Project	IEEE 802.16 Broadband Wireless Access Working Group < http://ieee802.org/16 >
Title	Harmonized Relay Frame Structure
Date Submitted	2009-01-13
Source(s)	<p>Jerry Sydir, Alexander Maltsev, Honggang Li, Alexei Davydov, Rui Huang Intel Corporation jerry.sydir@intel.com</p> <p>Rakesh Taori, Youngbin Chang Samsung Electronics rakesh.taori@samsung.com</p> <p>Shashikant Maheshwari, Adrian Boariu, Yousuf Saifullah Nokia Siemens Networks lsun@lge.com</p> <p>Li-Hsiang Sun , Ki-Dong Lee, Aeran Youn LG Electronics chen.yuqin@zte.com.cn liu.yang8@zte.com.cn qu.hongyun@zte.com.cn mchion@zteusa.com</p> <p>ZTE Corporation Jungnam Yun, Yerang Hur, Bong Ho Kim jnyun@posdata-usa.com</p> <p>POSDATA Co., Ltd. frank_ren@itri.org.tw richard929@itri.org.tw</p> <p>Fang-Ching (Frank) Ren, Richard Li ITRI *http://standards.ieee.org/faqs/affiliationFAQ.html></p>
Re:	TGm SDD CfC (IEEE 802.16m-08/052) – Section 14.4.4

Harmonized Relay Frame Structure

Text Proposal

Figure 33 Relay Frame structure ~~option 1~~

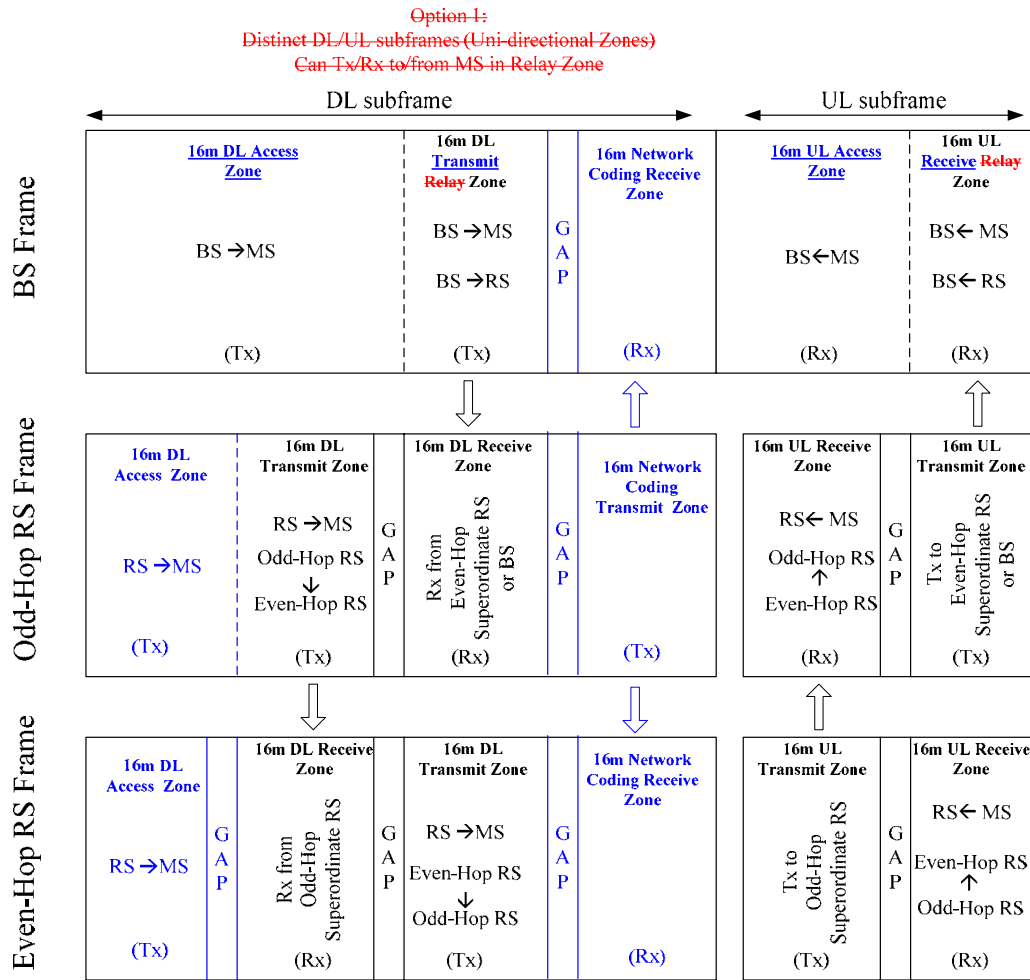
~~There are two options for the Relay frame structure. These are captured in Figure 33 and Figure 34. Further study is required to distill a single frame structure from among these two options. The Relay frame structure is illustrated in Figure 33.~~

[Modify figure 33 on page 68 as indicated below]

[Modify the caption of figure 33 on page 68 as indicated below]

- DL Access Zone: An integer multiple of subframes located in the 16m zone of the DL of the 16m BS frame or 16m RS frame, where a 16m BS or a 16m RS can transmit to the 16m MSs. SCH and BCH as well as unicast transmissions may be performed in this zone.

- DL Transmit Zone: An integer multiple of subframes located in the 16m zone of the DL of the 16m BS frame or 16m RS frame, where a 16m BS or RS can transmit to subordinate 16m RSs and the 16m MSs.

- DL Receive Zone: An integer multiple of subframes located in the 16m zone of the DL of the 16m RS frame, where a 16m RS can receive from its superordinate station.

- UL Transmit Zone: An integer multiple of subframes located in the 16m zone of the UL of the 16m RS frame, where a 16m RS can transmit to its superordinate station.
- UL Receive Zone: An integer multiple of subframes located in the 16m zone of the UL of the 16m BS frame or 16m RS frame, where a 16m BS or RS can receive from its subordinate 16m RSs and the 16m MSs.
- Network Coding Transmit Zone: An integer multiple of subframes located in the DL of the frame of the Odd Hop 16m RS which is directly attached to the BS, where an Odd Hop 16m RS can transmit network coded transmissions to the BS and Even Hop RS. Transmissions to the MS in this zone are FFS.
- Network Coding Receive Zone: An integer multiple of subframes located in the DL of the BS or Even Hop RS frame, where an BS or Even Hop 16m RS can receive network coded transmissions from the Odd Hop RS.

The Network Coding Transmit Zone is optional and is present only in the frame of a 16m RS which is directly attached to the BS. The Network Coding Receive Zone is optional and is present in the BS and Even Hop 16m RS frames only.
